Subject: Beaver Valley Power Station, Unit No. 1 and No. 2
BV-1 Docket No. 50-334, License No. DPR-66
BV-2 Docket No. 50-412, License No. NPF-73
NRC Bulletin 2003-02
BV-2 Lower Head Inspection 60-Day Report

Evaluation Report for 2R10

RPV Lower Head Penetrations

Responses to NRC Teleconference Questions

Figure 1: Locations of residue observed in or near penetration annulus.

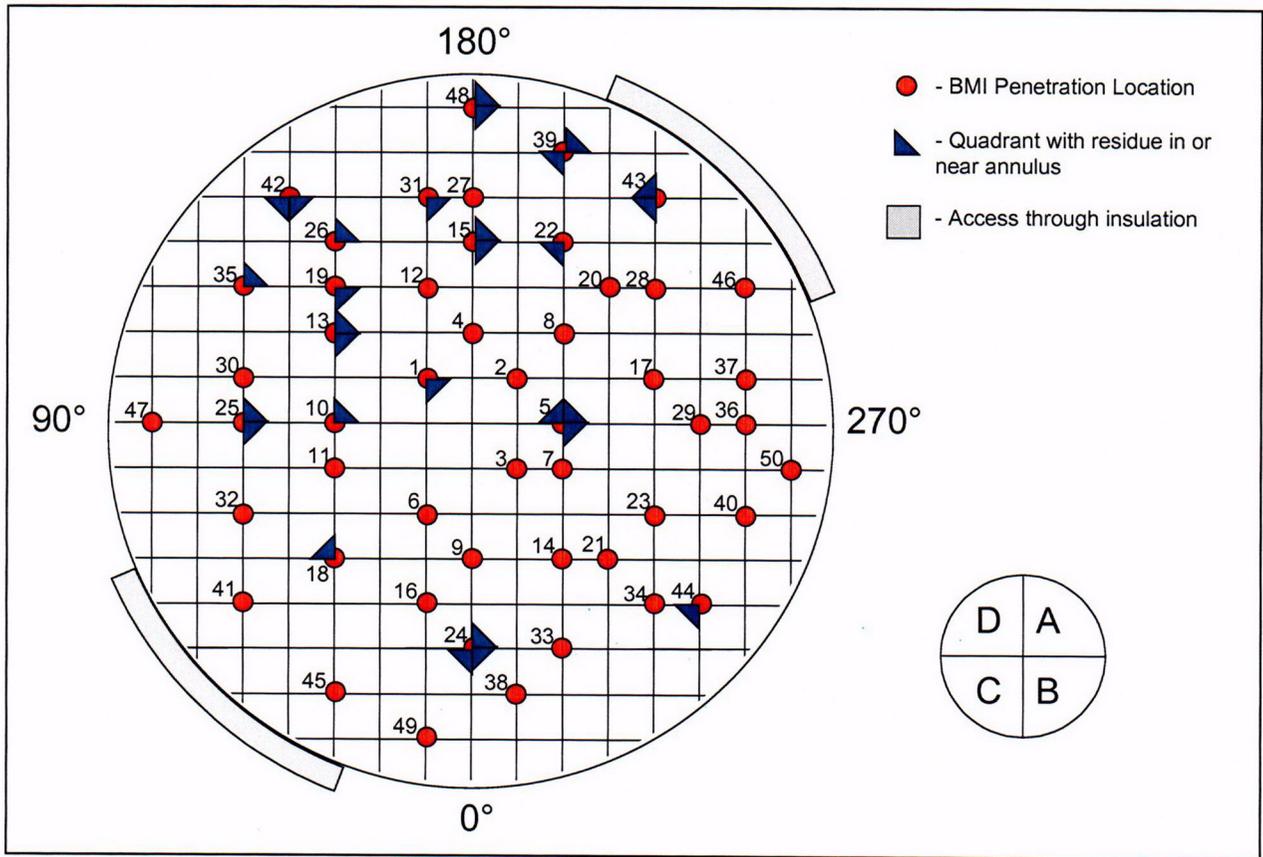
c. Is there any particular location of the penetration where the deposit is more predominant (i.e., the hill side of the vessel....). A picture depicting the BMI tubes and the locations of the deposits would be beneficial.

As shown in Figure 1 of this response, residue was observed in or near the annulus on the uphill, downhill, and sidehill orientations. The residue observed on the boss around many penetrations is randomly oriented in all directions. As shown in Figure 2, similar residue is observed on the vessel surface as well.

Figure 8: BVPS Unit 2 reactor vessel with Spraylat coating applied.

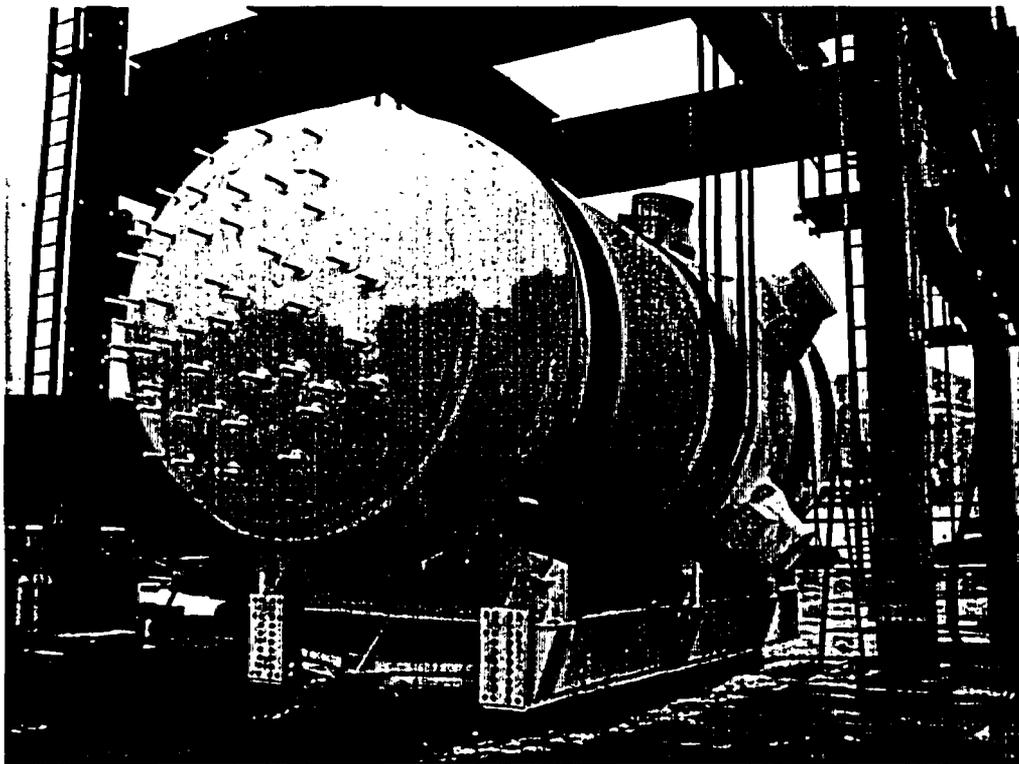
4. *Discuss whether there are any photographs of the lower head since fabrication that would support your root cause.*

3. *Discuss what you have learned about the tape/paint from review of original construction records. Were any previously taken photographs of the lower vessel head available?*

Figure 8 shows the Unit 2 vessel with the Spraylat coating applied. Figures 10 and 12 show images of two other vessels in the packaged configuration, both fabricated by Combustion Engineering and of similar vintage. The method in which the vessel was packaged is clearly visible in each case.

The only picture obtained of the BVPS Unit 2 lower vessel head is shown in Figure 8. Figures 10 and 12 show two CE-fabricated vessels of similar vintage in their packaged configuration. Since installation, the BVPS Unit 2 lower head insulation had not been removed until 2R10. Thus, no previous pictures of the residue exist.

Figure 13: Streaking on Penetration 39 (a) and similar streaking on vessel surface and insulation uphill of Penetration 39 (b).

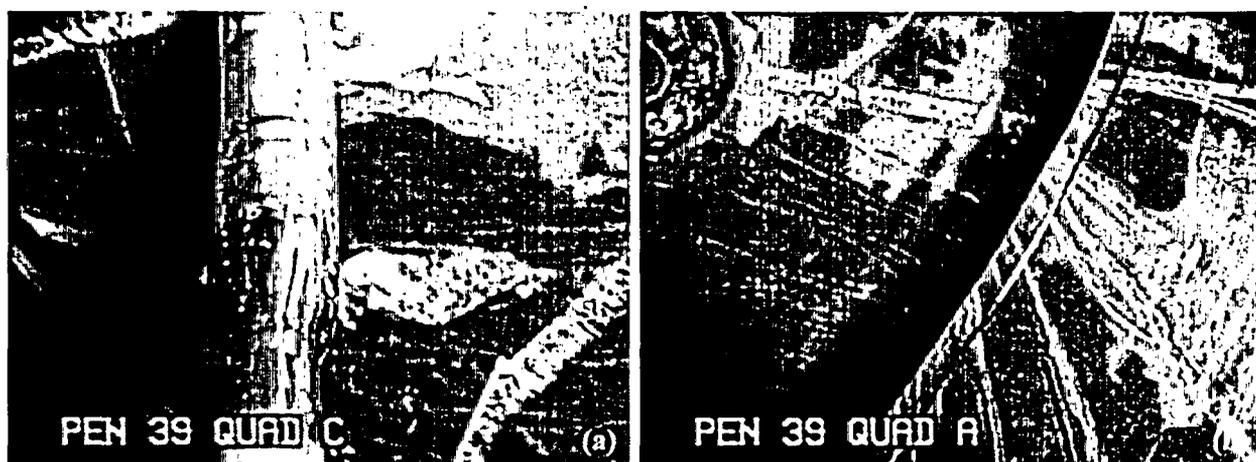
2. *Please discuss whether any "deposits" were found on the surface of the insulation facing the head. Please discuss how these "deposits" would appear both in the annulus and on the tube if the root cause was it was paint or tape placed on the head during the fabrication.*

7. *Penetration 39, quadrant C appears to have streaking down the instrumentation tube. Is this the case (or is it an artifact of the lighting angle)?*

In some locations, milky white streaking was observed on the surface of the insulation facing the head, presumed to be the result of previous reactor cavity seal leakage from above. The streaks were of no discernable thickness. The streaking observed is shown in Figure 13b.

The streaking on Penetration 39 appears milky white in color, has no discernable thickness, and is not visually characteristic of penetration leakage (Figure 13a). Inspection of the vessel surface uphill of Penetration 39 shows streaking on the side of the vessel and insulation panels as well (Figure 13b), leading to the conclusion that previous reactor cavity seal leakage likely ran down the side of the vessel and onto the surface of Penetration 39, leaving a thin milky white stain.
